Access Compliance Report

Public Rights-of-Way

(Curb Ramps)

Intersection ID: 43674	Main Street: ARMOUR RIDGE DR	Cross Street: ASHETON CREEK DR	Location: E
ADA ID: EEDFF60966D4	Ramp Type: PerpDiag	Initial Pass/Fail: Fail	Overall Compliance: No
Severity Score: 21.25			
Codes/Mitigation Info/Possible Solution		Field Measurements/Component Compliance

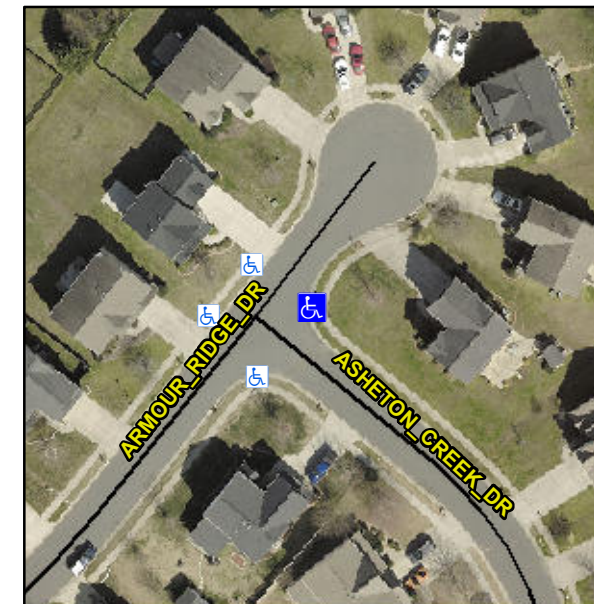
Not Found, R304.5.1, R304.2.2

Compliance	Description	Data	Compliance	Description	Data
N/A	Ramp Length (in)	46.0	No	Ramp Slope (%)	9.2
No	Ramp Width (in)	37.0	Yes	Ramp XSlope (%)	1.5
N/A	Flare Type LT	N/A	N/A	Flare Type RT	N/A
N/A	Flare Slope LT (%)	N/A	N/A	Flare Slope RT (%)	N/A
N/A	Flare Traversable LT?	N/A	N/A	Flare Traversable RT?	N/A
N/A	Landing Length (in)	N/A	N/A	DWS Provided?	N/A
N/A	Landing Width (in)	N/A	N/A	DWS Contrast?	N/A
N/A	Landing Slope (%)	N/A	N/A	DWS Length (in)	N/A
N/A	Landing X Slope (%)	N/A	N/A	DWS Full Width?	N/A
N/A	Landing Curb? (Y/N)	N/A	N/A	DWS Offset (in)	N/A
N/A	Shared Landing?	N/A			
N/A	Gutter Ponding?	N/A	N/A	Gutter Slope (%)	N/A
N/A	Gutter Lip Ht (in)	N/A	N/A	Gutter X Slope (%)	N/A
N/A	Painted X Walk1?	No	N/A	Painted X Walk2?	No
	X Walk 1 Direction	To NW		X Walk 2 Direction	To SW
N/A	X Walk 1 Width (in)	N/A	N/A	X Walk 2 Width (in)	N/A
	X Walk 1 Slope (%)	1.1		X Walk 2 Slope (%)	3.5
	X Walk 1 X Slope (%)	1.6		X Walk 2 X Slope (%)	1.2

Remove & Replace Curb Ramp With Two New Directional Ramps or Equivalent.
